**RESTORATION “AS-BUILT” REPORT AND ADDENDUM  
TO  
CONCEPTUAL HABITAT RESTORATION AND  
REVEGETATION PLAN,  
2825 PADARO LANE, SUMMERLAND,  
SANTA BARBARA COUNTY, CALIFORNIA**

**25 May 2012**

**Hunt & Associates Biological  
Consulting Services  
5290 Overpass Road, Ste. 108  
Santa Barbara, CA 93111**

**Figure 2. “As-Built” vs. Approved Plan Planting Density.**

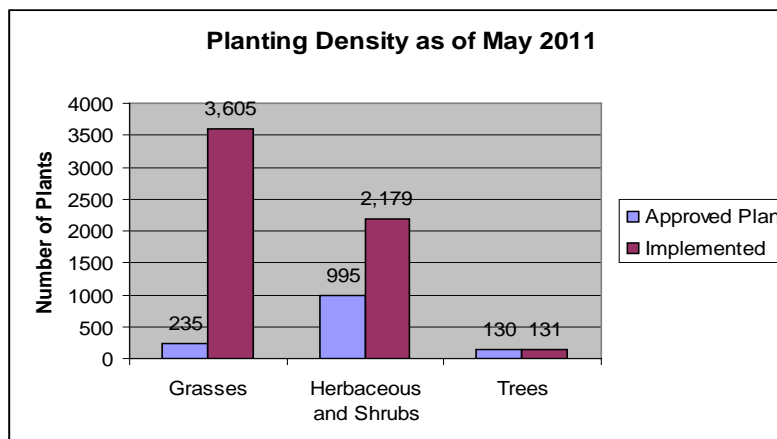
Species richness and planting density under “as-built” restoration is over three to four times greater than that proposed in the Approved Plan (Figs. 2 and 3). Approximately 4,555 additional plants, comprising 61 additional species, were planted in the restoration area.
